Changes to P802.3cc D3.2 for reflections

Pete Anslow, Ciena

IEEE P802.3cc Task Force, August 2017

LR 0.7 dB penalty as proposed worst case

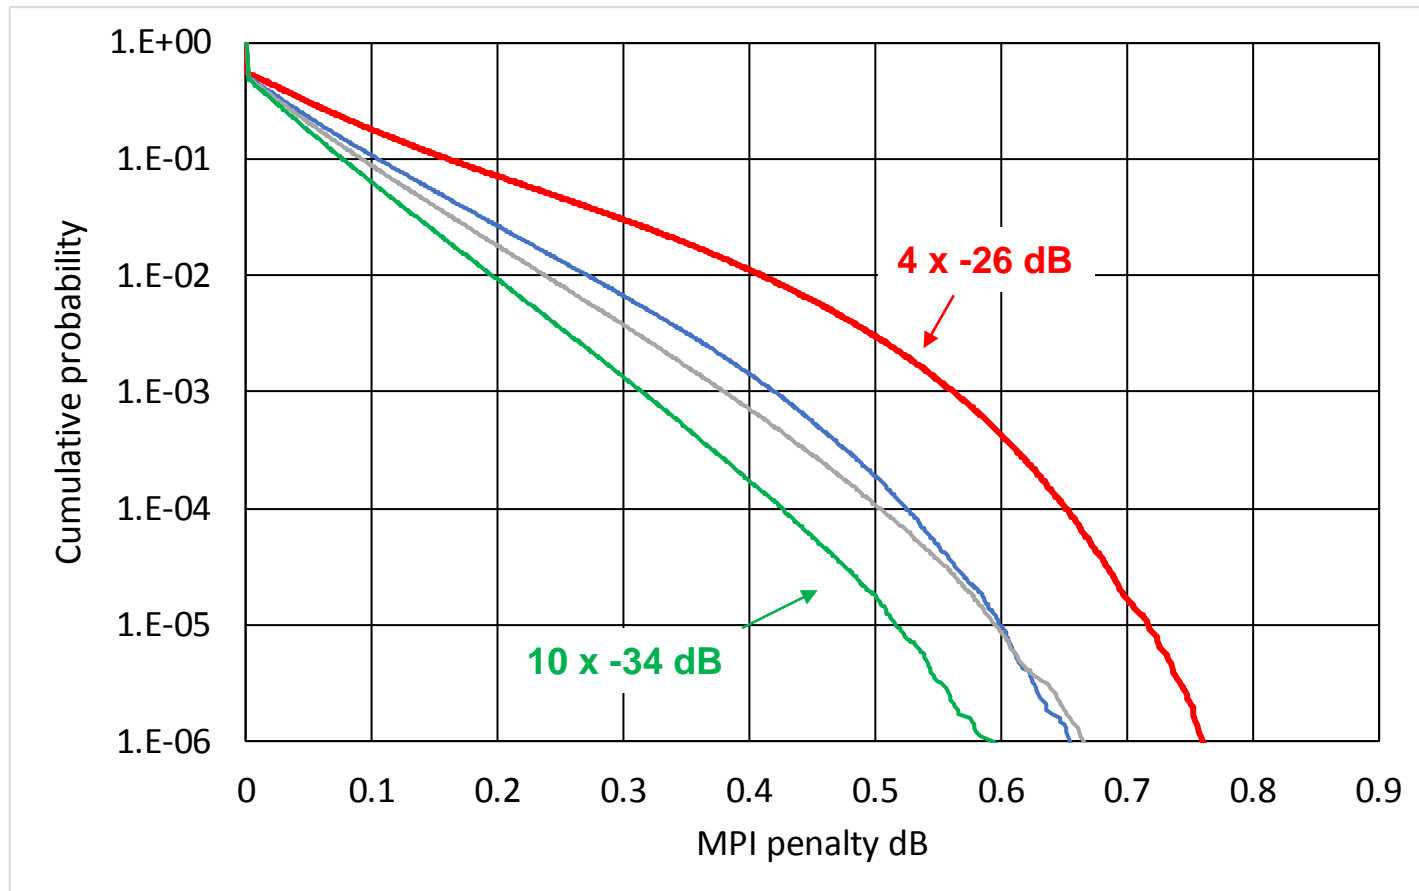
-26	-34	-34	-34	-34	-34	-34	-34	-34	-34	-34	6.3	-26
-26	-32	-32	-55	-32	-32	-32	-32	-55	-32	-32	6.3	-26
-26	-30	-55	-55	-30	-30	-30	-30	-55	-55	-30	6.3	-26
-26	-26	-55	-55	-55	-26	-26	-55	-55	-55	-26	6.3	-26

LR 0.7 dB penalty 4 x -26 more realistic versions

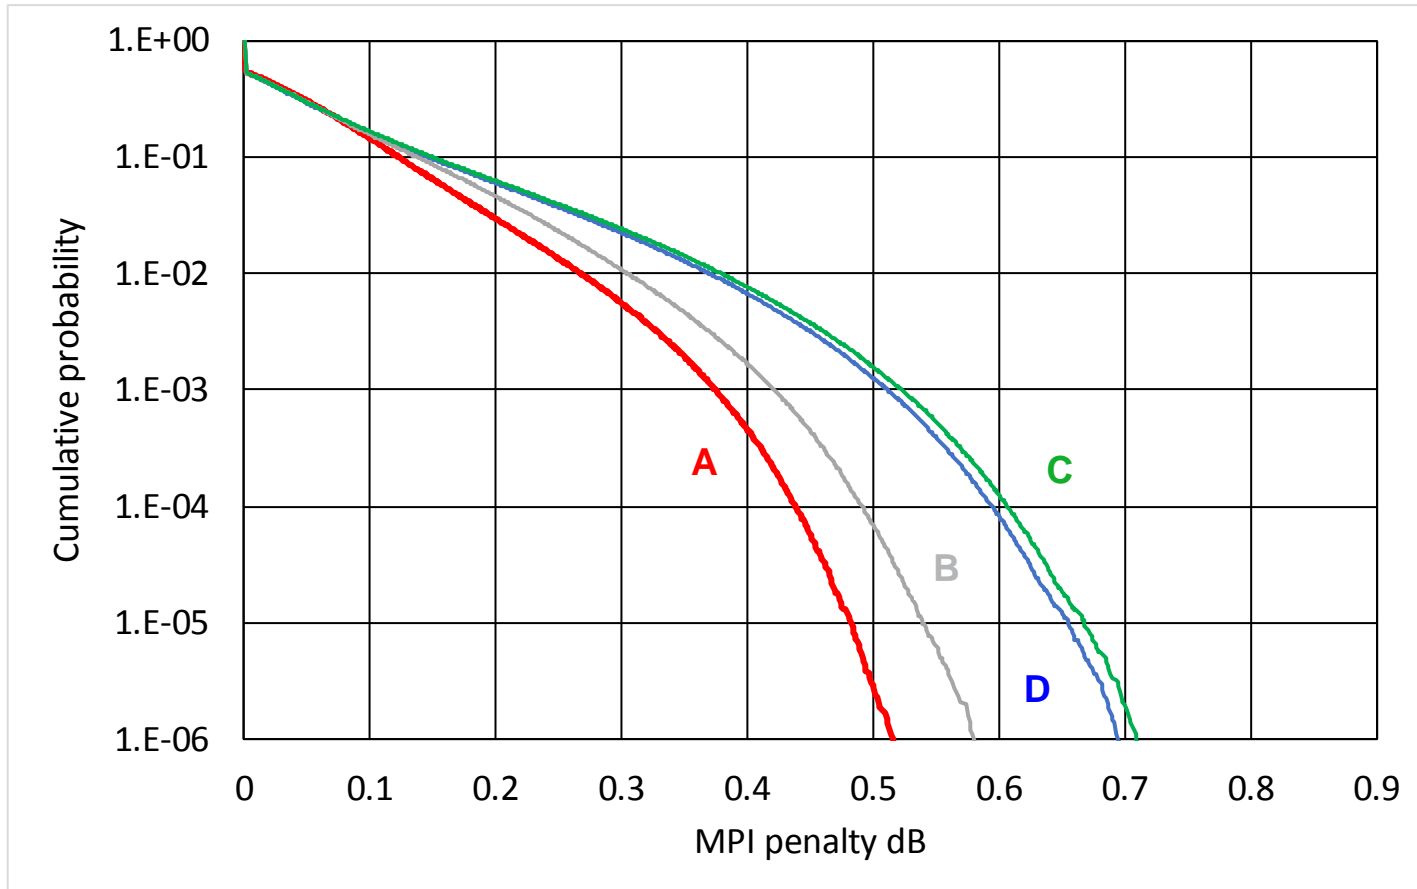
A	-26	-26	-55	-55	-55	-26	6.3	-26	-55	-55	-55	-26	-26				
B	-26	-26	-55	-55	-55	-26	-26	-55	-55	-55	6.3	-26	-26				
C	-26	-26	-55	-55	-55	-26	0.5	-26	-55	-55	-55	-26	5.8	-26			
D	-26	0.2	-26	-55	-55	-55	0.2	-26	0.2	-26	-55	-55	-55	0.2	-26	5.5	-26

As shown on slide 11, if the lumped loss is nearer the middle of the link, or a small amount of the total loss is associated with each connector, the calculated MPI penalty comes within the 0.7 dB budget.

LR 0.7 dB penalty conservative option

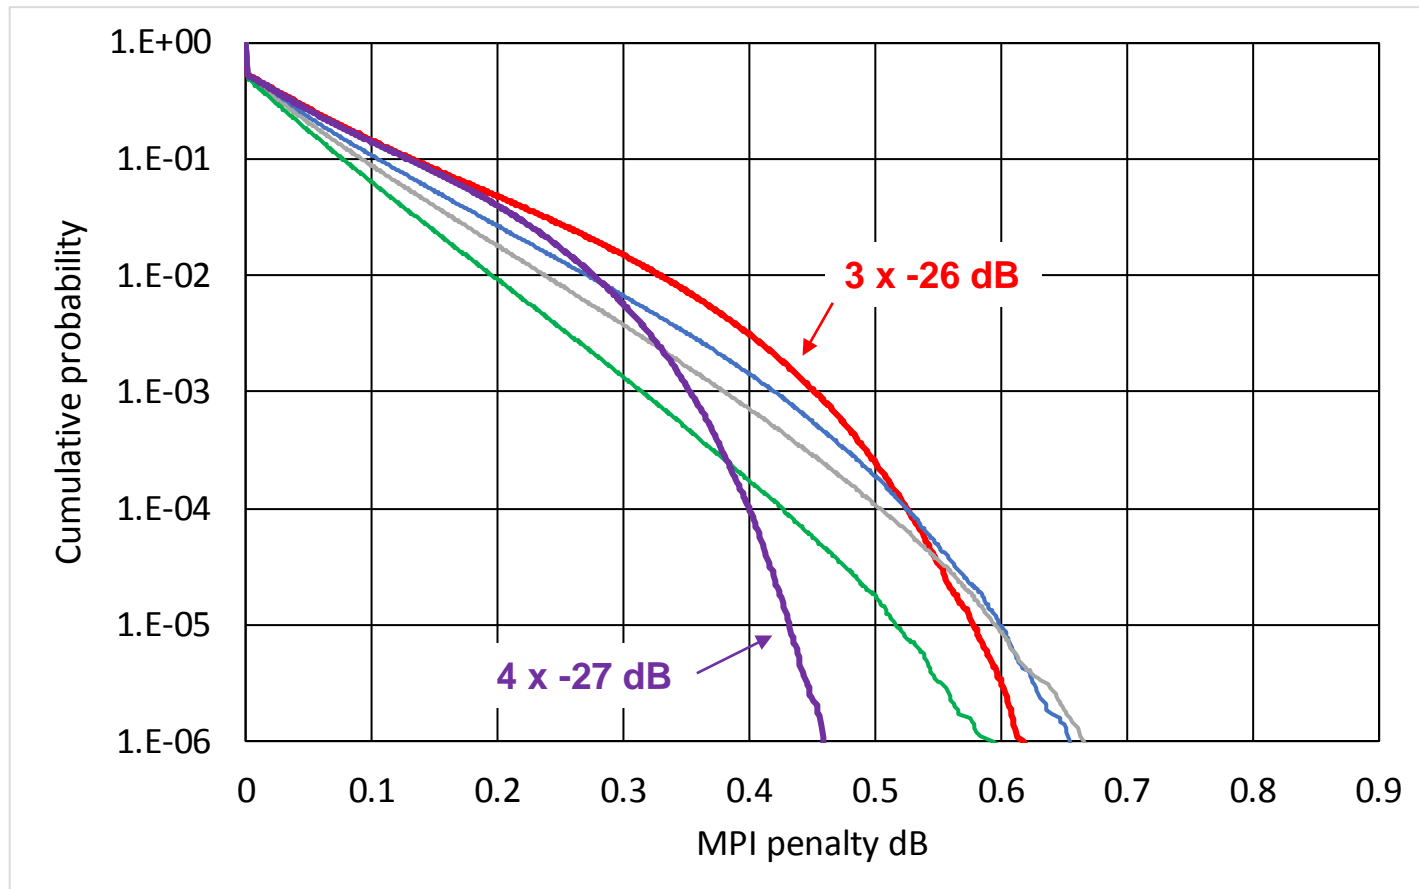
-26	-34	-34	-34	-34	-34	-34	-34	-34	-34	-34	6.3	-26
-26	-32	-32	-55	-32	-32	-32	-32	-55	-32	-32	6.3	-26
-26	-30	-55	-55	-30	-30	-30	-30	-55	-55	-30	6.3	-26
-26	-27	-55	-55	-55	-27	-27	-55	-55	-55	-27	6.3	-26
-26	-26	-55	-55	-55	-55	-26	-55	-55	-55	-26	6.3	-26

While the 4 x -26 dB + 6 x -55 dB case with all of the 6.3 dB of loss just before the receiver shows an MPI penalty at a probability of 1E-6 slightly above the 0.7 dB allocated in the budget, this scenario is very unrealistic as some portion of the 6.3 dB loss is bound to occur due to the 10 connectors in the link.

It is therefore proposed to set the maximum number of -26 dB reflectances in Table 114-13 on slide 6 to four.
